CITY OF ALBUQUERQUE

**RE: Medical Clinic
7439 Alameda Blvd NE
Grading and Drainage Plan
Engineer's Stamp Date: 02/04/19
Hydrology File: C19D067**

Based upon the information provided in your submittal received 02/05/2019, the Grading and Drainage Plan is approved for Building Permit and SO-19 Permit.

| | GRADING AND DRAINAGE PLAN | |

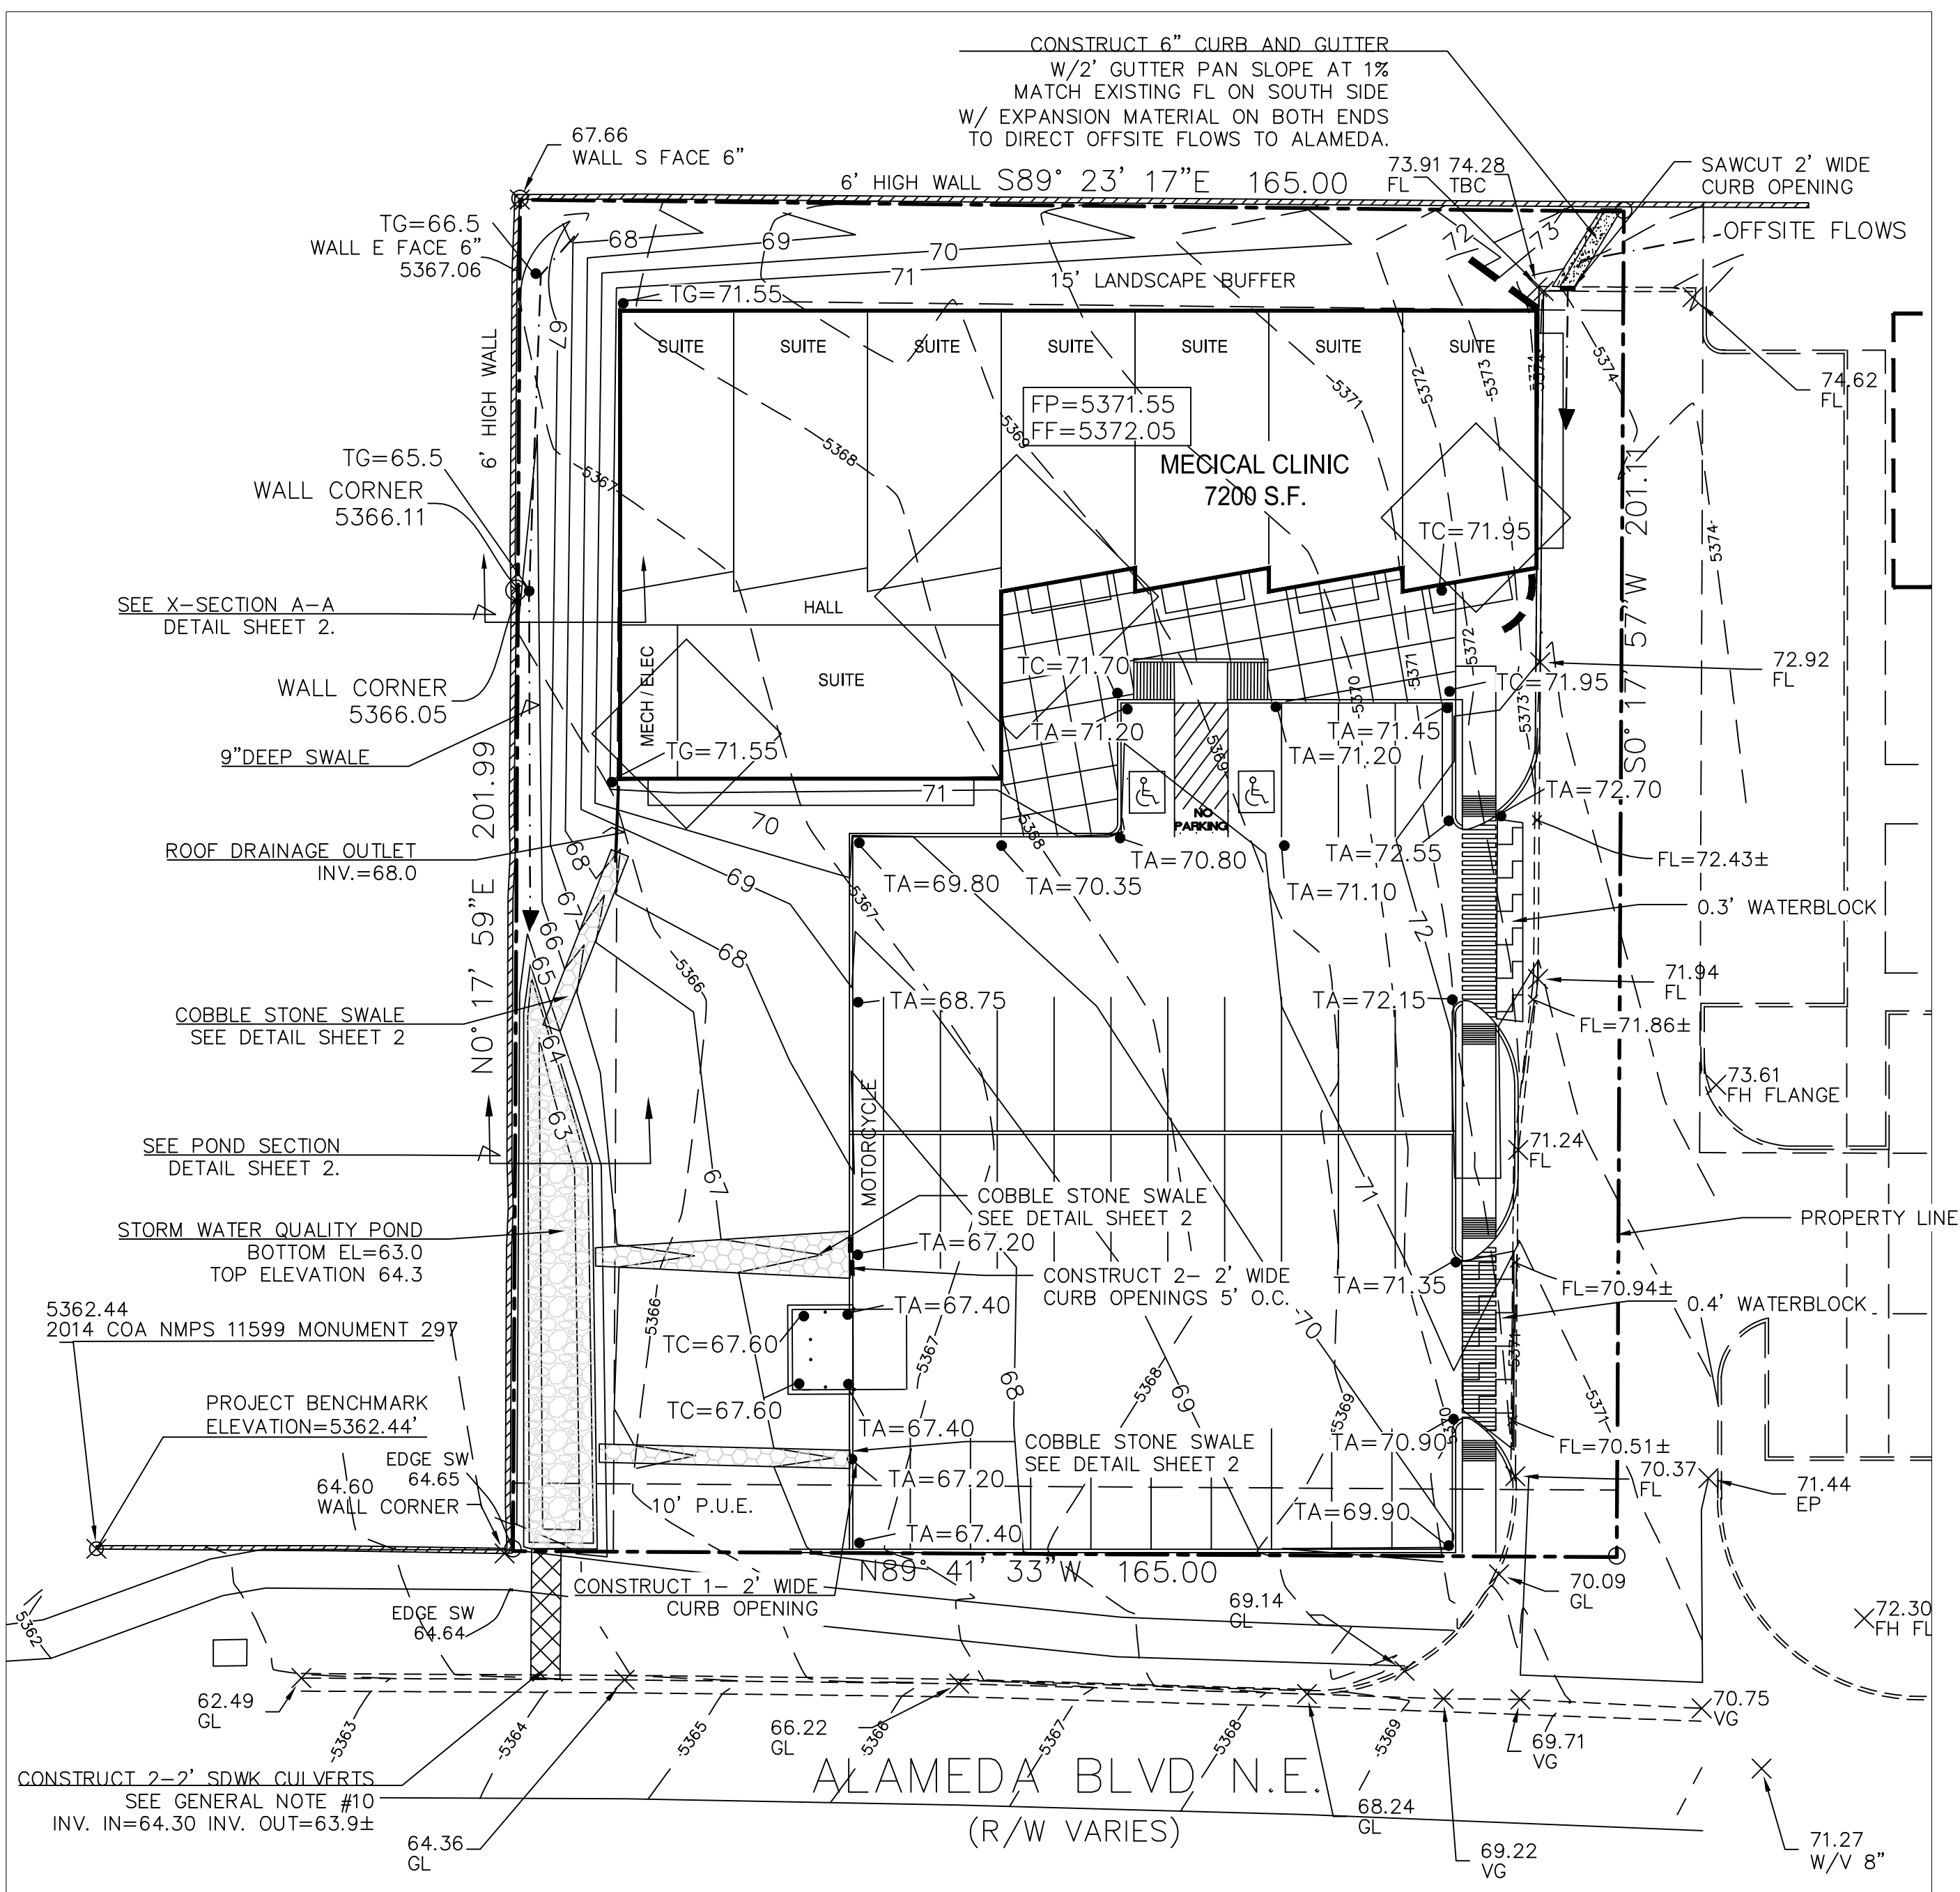
Please provide Drainage Covenant per Chapter 17 of the DPM prior to Permanent Release of Occupancy for the stormwater quality pond. Please submit these to the 4th floor of Plaza de Sol. A \$25 fee for each will be required.
